UNITED STATES PATENT AND TRADEMARK OFFICE

APPLICATION NO.	FILING DATE	FIRST NAMED INVENTOR	ATTORNEY DOCKET NO.	CONFIRMATION NO.
10/538,010	06/03/2005	Shinichi Ookubo	040894-7251	6869

Office Action Summary

DETAILED ACTION

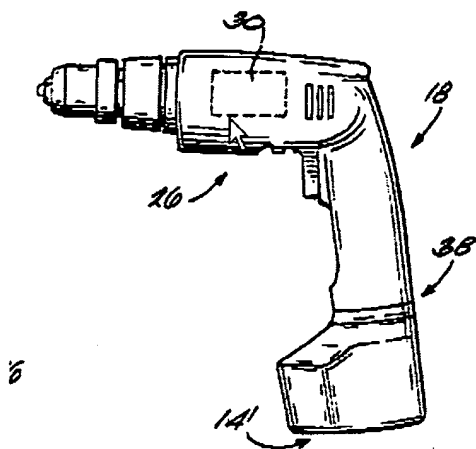
Kubale discloses in figures 1A-11B a cordless power tool 18

a power supply 14 of a motor 54 [see fig.1A],

along an opening axis 50. In this configuration, a motor terminal assembly 54 (schematically illustrated in FIGS. 3B and 4B) is

and rechargeable by an external power supply [see fig.2A; column 6, lines 12-16].

(6) As shown in FIGS. 2A, the battery charger 22 includes a charger housing 58 and a charging circuit 62 (schematically illustrated in FIGS. 3A and 4A) supported by the charger housing 58 and electrically connectable to a power source (not shown) and to a battery to charge the battery. In the illustrated

a charging electrode provided in the tool main body 62.

Kubale does not disclose the power supply including a plurality of electric double layer capacitors, and a series parallel switching circuit that switches the plurality of electric double layer capacitors into parallel connection when a start switch is off, and switches the plurality of electric double layer capacitors into series connection when the start switch is on.

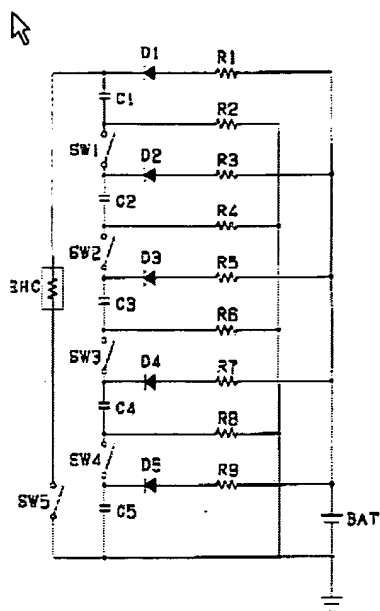
JP-09285006 discloses in the abstract and figures 1-2

a power supply comprising a plurality of capacitors C1-C5 and a battery BAT to supply large electric power while minimizing a burden and bad effect on a storage battery. Therefore, it would have been obvious to a person having ordinary skill in the art at the time the invention was made to modify Kubale's apparatus and include the power supply, as disclosed by JP-09285006, in order to supply large electric power while minimizing a burden and bad effect on a storage battery.

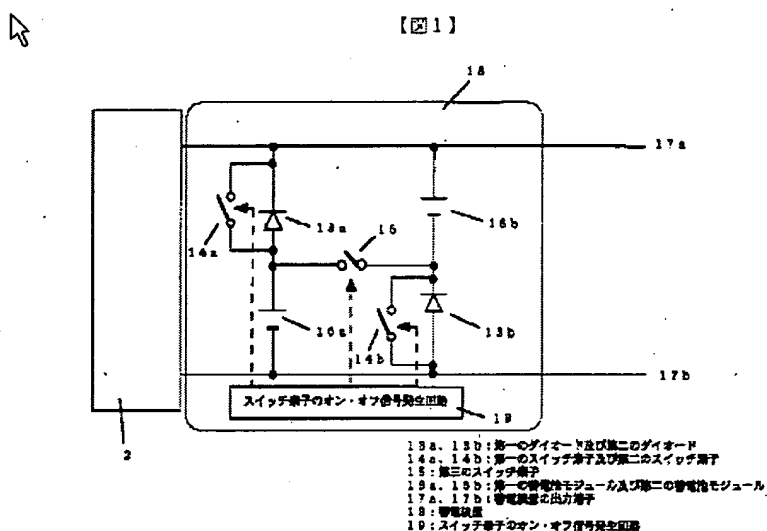
As to the use of an electric double layer capacitor, absent any criticality, is only considered to be the use of "optimum" or "preferred" material that a person having ordinary skill in the art at the time the invention was made using routine experimentation would have found obvious to provide for the capacitor disclosed by Kubale and Wang in order to accommodate application specifics since it has been held to be a matter of obvious design choice and within the general skill of a worker in the art to select a known

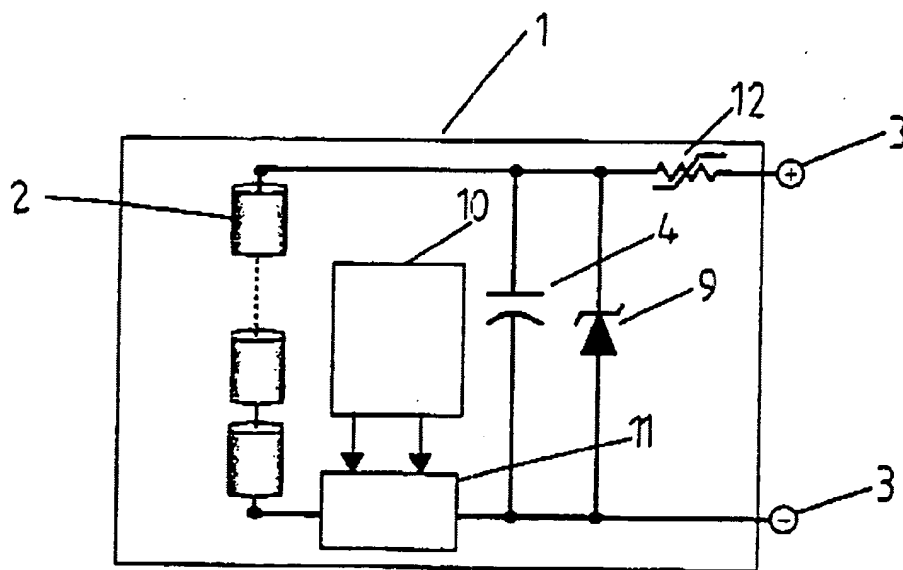
7. Applicant's arguments with respect to the claims have been considered but are moot in view of the new grounds of rejection, and the revisions to the claims, which are new issue.
